CCONSERVATION COMMISSION DETAILED AGENDA

Date: November 16, 2023

1. 505 Main Street– NOI – Commercial property redevelopment – DEP File #300-XXXX

2. 241 & 245 Main Street –NOI – Paving of a commercial parking lot – DEP File #300-XXXX

GRADING & DRAINAGE PLAN
MULTI-FAMILY RESIDENTIAL PROJECT
505 MAIN STREET, STURBRIDGE, MA 01518

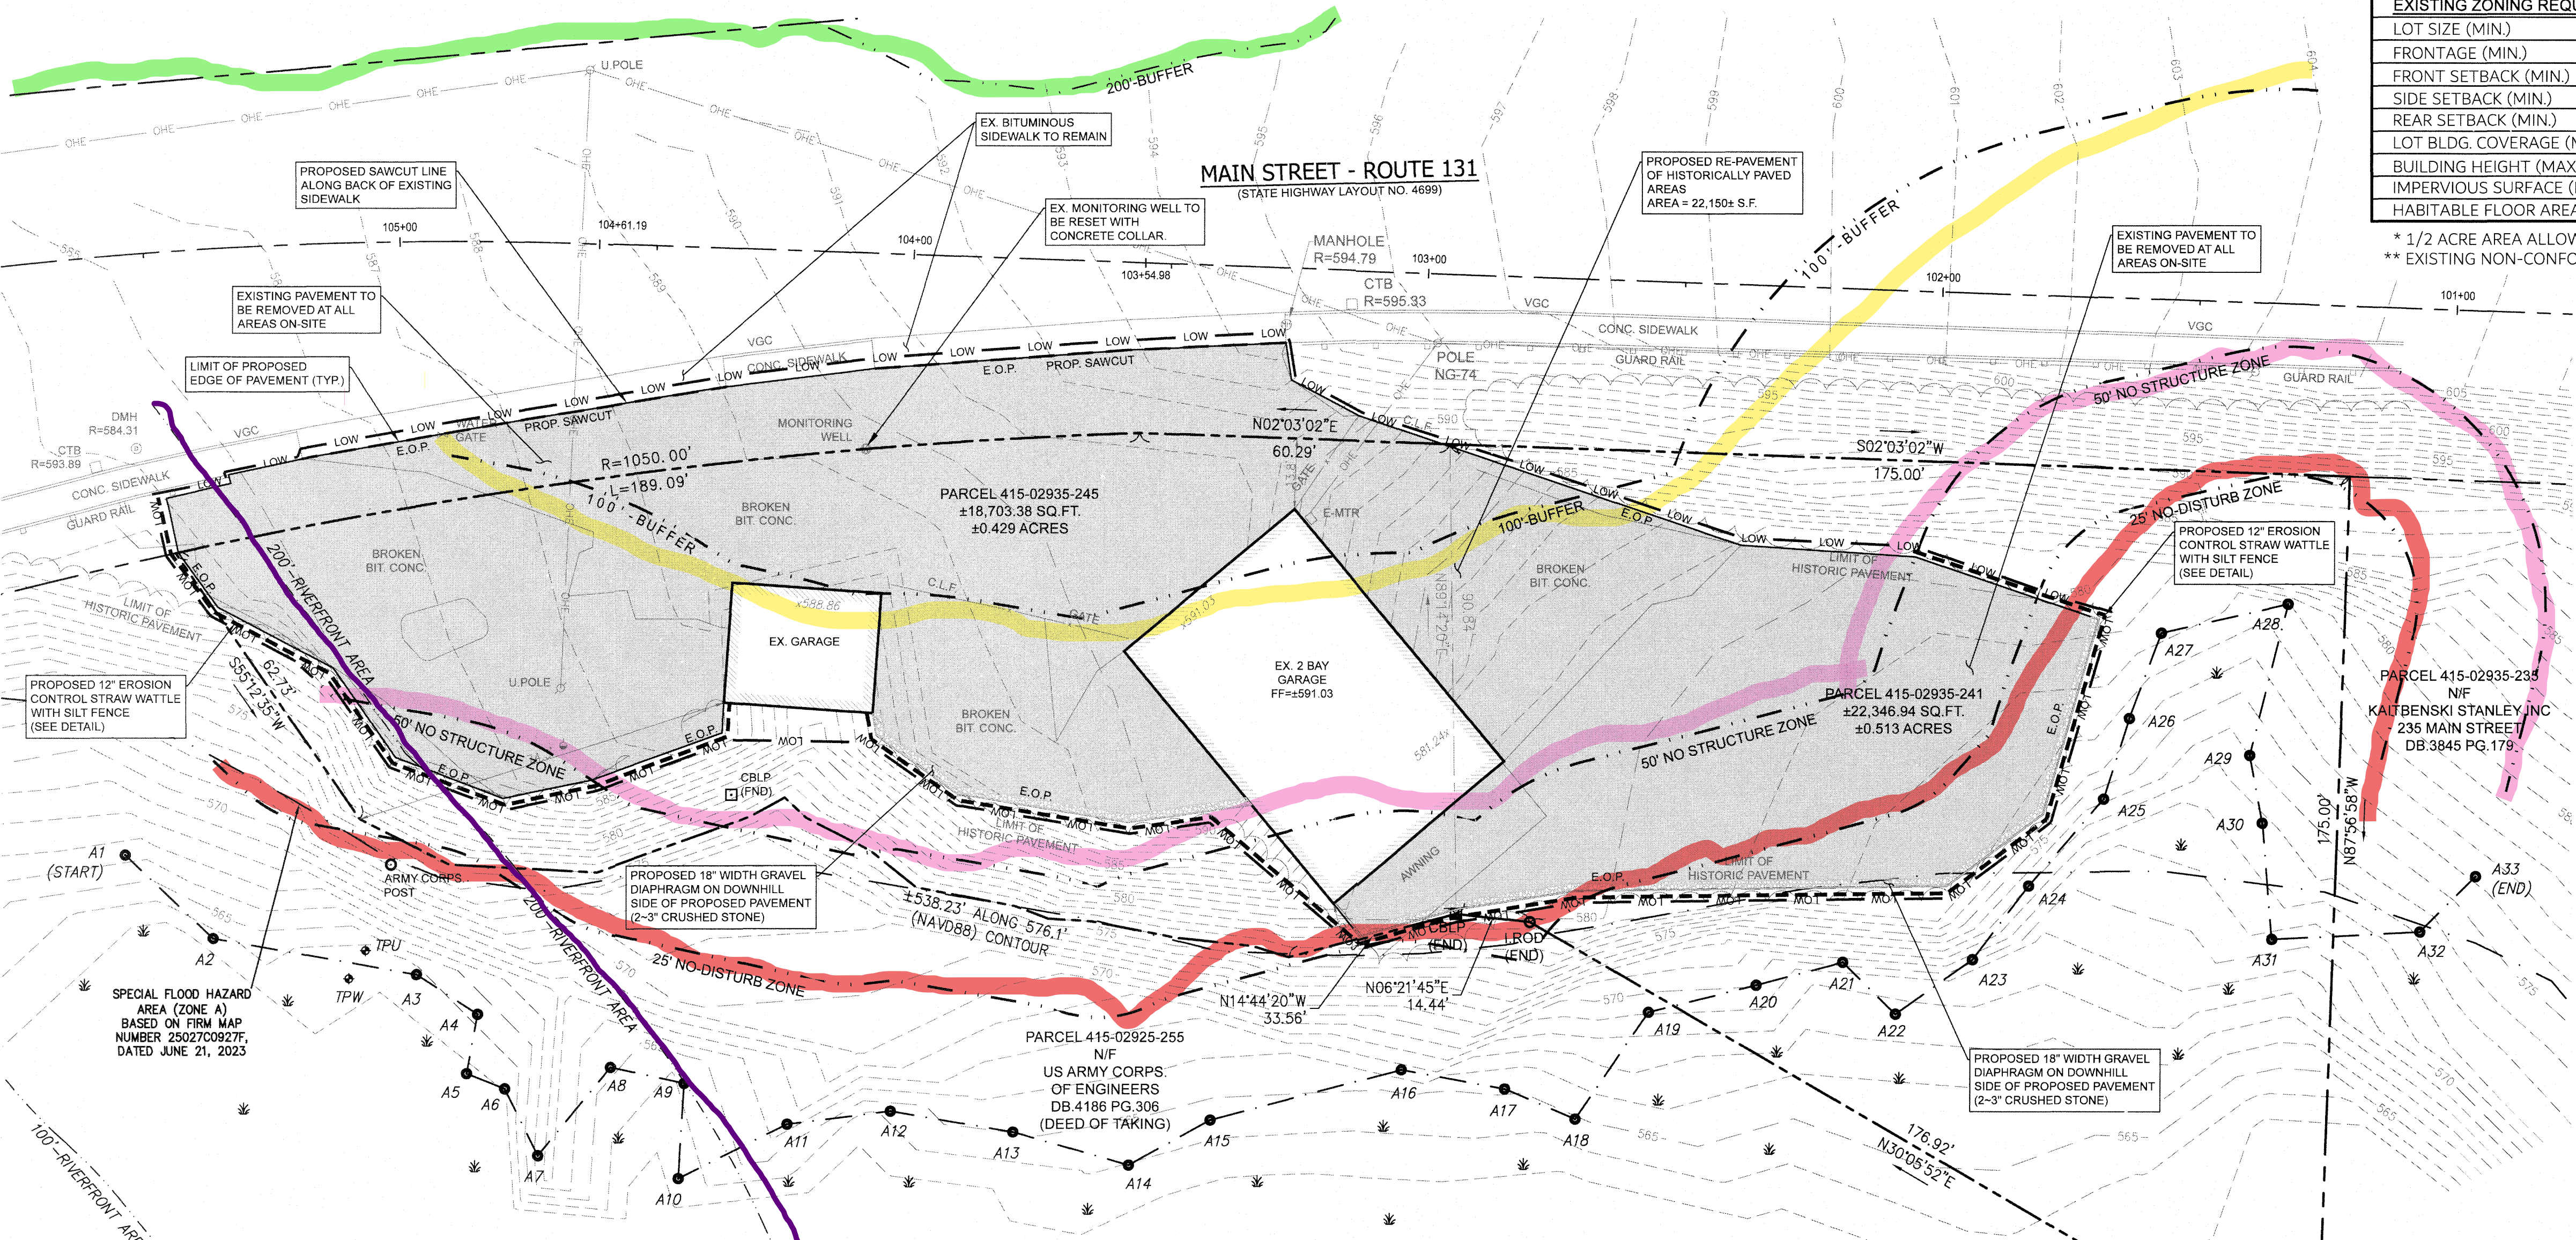
- Project was filed in January of 2023 but was withdrawn. Project appears to have been revised since original submission. Narrative does not include details on revisions from original plan but appears rain garden revised to move further from wetlands.

- As project includes an increase of impervious surface, the project is considered a new project per MA Stormwater Standards. Staff are pleased to see the use of the bioretention basin for stormwater management. Stormwater report and supporting documentation appears to cover standards. O&M plan includes use of salt alternatives. Snow storage area shown on the plan. Project is within a Zone II wellhead area which is a critical area and stormwater management requirements indicate to have been met for this.

- Project includes new paved parking areas within the 50' no new structure setback. There is some existing and deteriorating/remnant pavement within this area. Per Bylaw Regs definitions a structure includes: "Any man-made or man-assembled impervious or partially impervious combination of materials and includes but is not limited to buildings, asphalt driveways, retaining walls, patios, swimming pools, sheds (decks, porches), framework, or any part thereof existing on, above or below the level of land or water."

- Plan shows asphalt pavement covered with brush. This area has a significant amount of Japanese knotweed growing within it. The proper removal of the invasive is recommended.

- Project would require a waiver. Waiver was not requested. Applicant should review waiver requirements and provide the required information in order for the board to consider it. Can project be revised to eliminate some of paved areas at rear of lot to meet standards? The removal of the back two parking spots could allow for the rain garden to be elongated and for the outlet discharge and outlet protection to be removed from the 25' no disturb. This could be a good alternative towards a waiver. The area of the outlet discharge is within what a vegetated area in the 25' no disturb and would appear to be a new disturbance. Mitigation would be required. Are there opportunities to increase tree cover on lot which could shade paved parking areas?

- Board of Health comments-There is Town water and sewer here. The only comment on this project is that the pad for the dumpster does not appear to be large enough. We suggest review of dumpster sizes and to create a pad large enough to accommodate trash AND recycling dumpsters as required by State and local regulations

NOTICE OF INTENT PLAN
241 & 245 MAIN STREET
STURBRIDGE, MA 01566

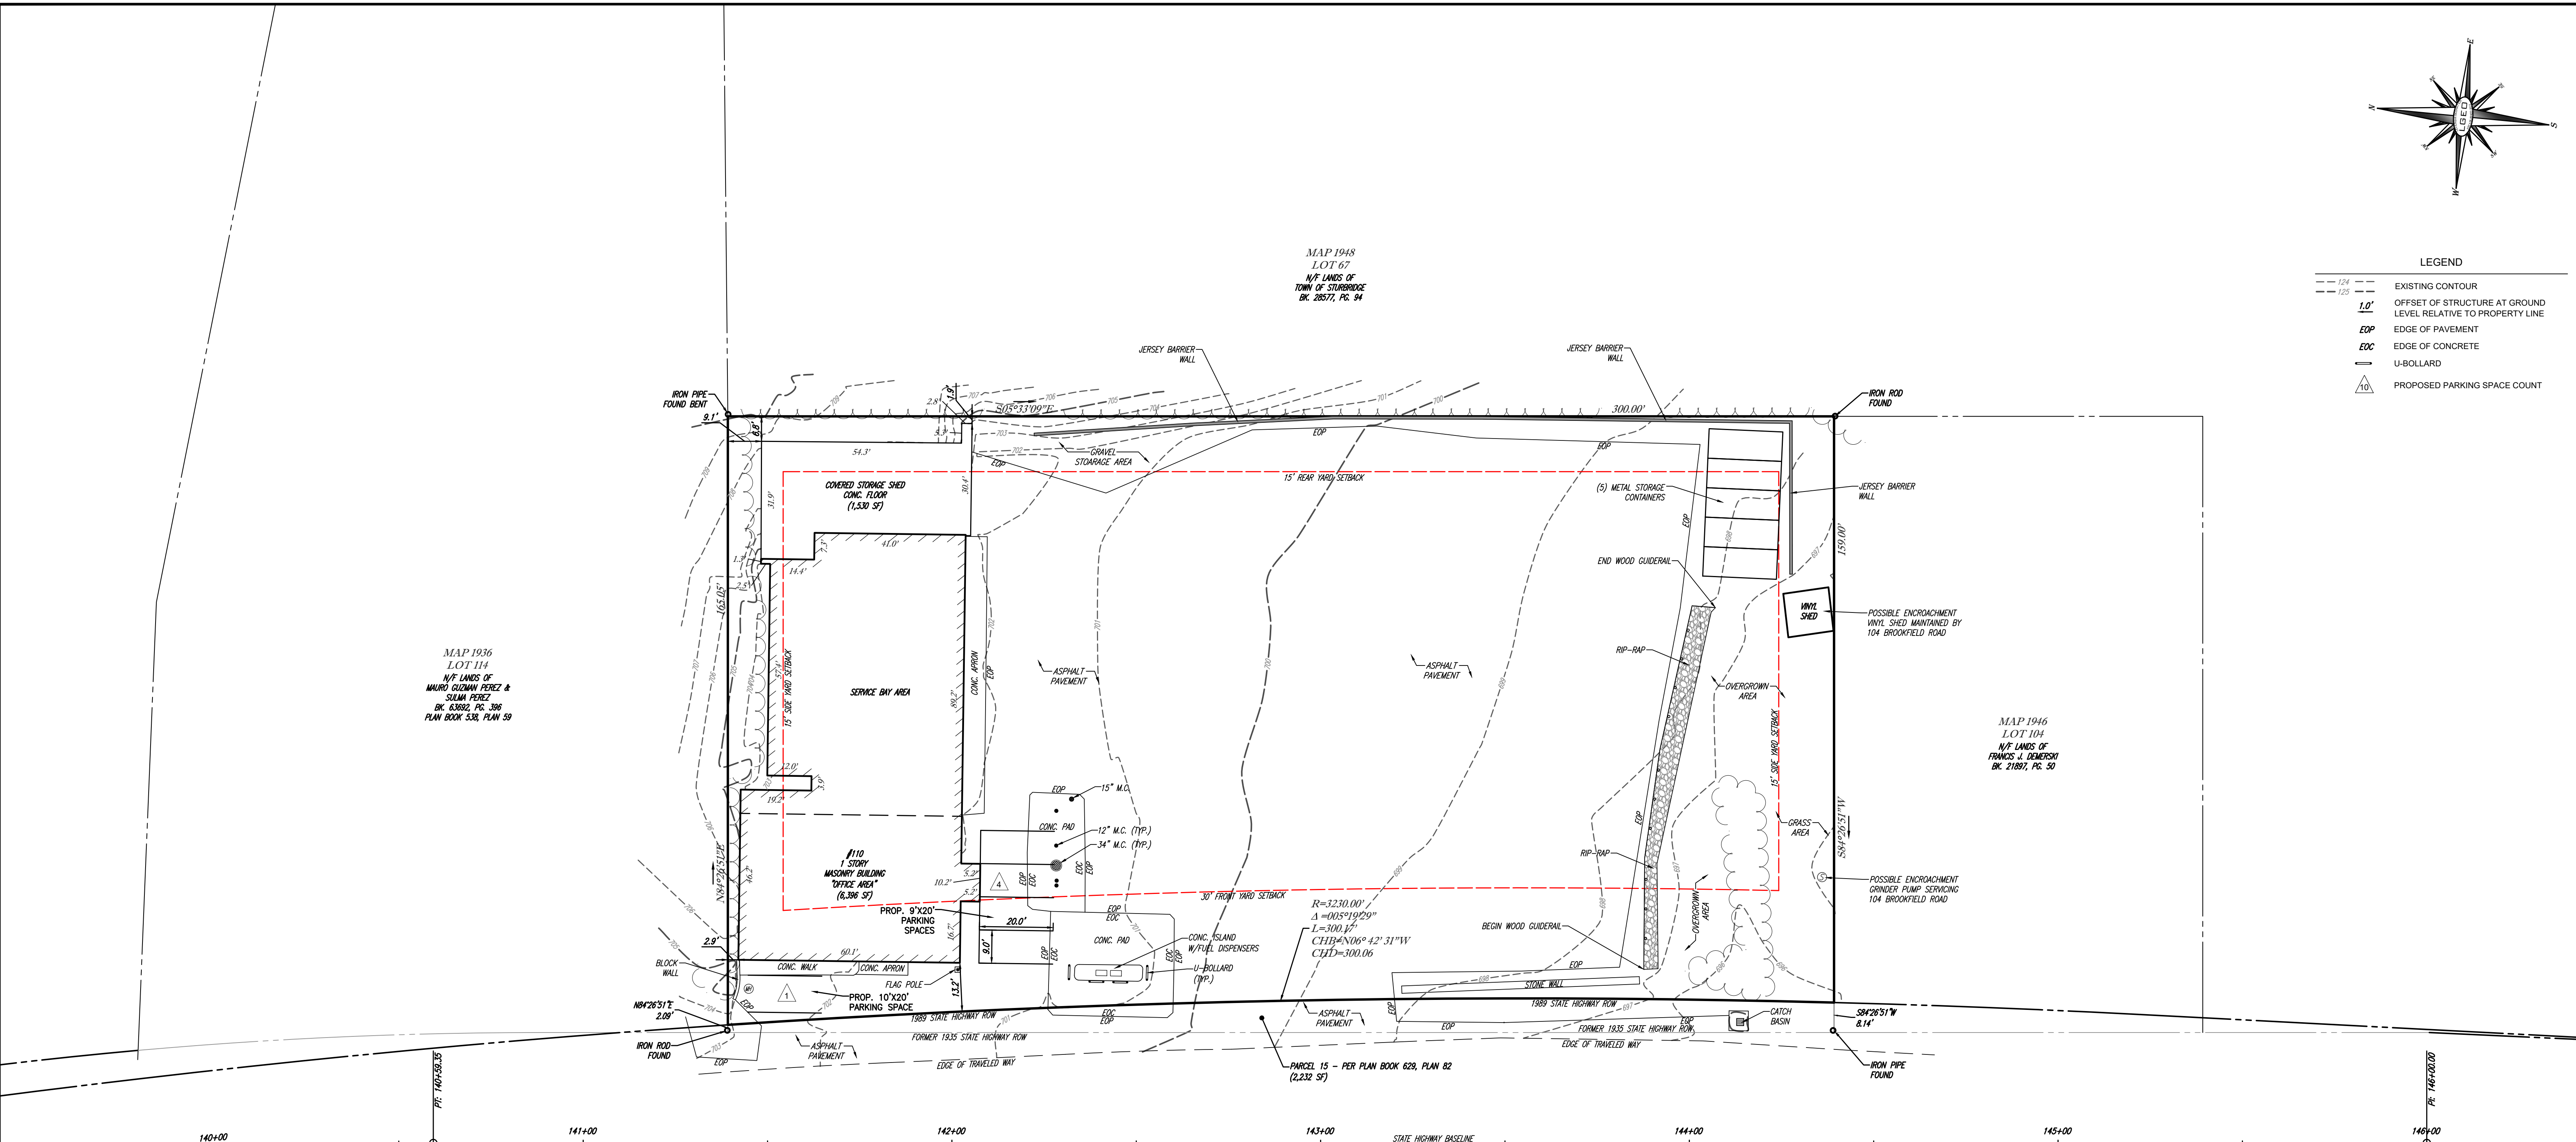
- DEP file number not issued to date.
 - Proof of legal ad received.
 - Project site is not located within Priority & Estimated Habitat.
 - Site noted to be within buffer zone to a Bordering Vegetated Wetland, contains BLSF and small portion of site shown as Riverfront Area. CMG notes area adjacent to BVW associated with a tributary to Hobbs Brook. Review of area shows that is in fact Hobbs Brook. How was Riverfront Area established? Area appears ponded but part of Hobbs Brook.

- Portion of site shown as Zone A. Bordering Land Subject to Flooding corresponds with the 100-year floodplain. Zone A FEMA flood zones cannot be used to define the limit of BLSF. The location of BLSF should be established using the criteria in 310 CMR 10.57(2)(a)(3). Any work within BLSF must meet the performance standards contained in 310 CMR 10.57(4).

- Full depth pavement restoration proposed to include removal of 6’ of subsurface and 4’ of pavement.
 - Site visit conducted. Some of the areas shown as historic pavement are gravel areas. Project would appear to result in increase of impervious surfaces over existing conditions and needs to meet standards for new development.

- Project shown as redevelopment for stormwater standards. This doesn’t appear accurate based on existing conditions. Much of site is currently gravel. Site is also noted as a towing facility which is a Land Use with a High Pollutant Load and BMPs are needed for control of pollutants associated with this use. Site noted only proposed to be re-paved. Therefore, no changes in runoff stated. Stated that paving will decrease sediment runoff. Gravel (2-3” stone) shown downgradient of proposed pavement. No BMPs proposed for infiltration or treatment. It appears that the owner’s intent to upgrade the site is in good intent, however, due to the resource areas present stormwater standards and WPA and SWB criteria need to be met. Adding BMPs for infiltration and treatment would be a benefit and appears required.

- Engineer to verify BLSF limits, RA limits and design project to meet criteria outlined in Regulations and with stormwater standards.
- Keith Beecher of the ACOE contacted staff with concerns in regards to property line discrepancies and encroachment onto ACOE land. He also contacted CMG staff. This will need to be addressed. Email attached.
- Staff Recommendations: Continue project to address comments and for DEP File #.
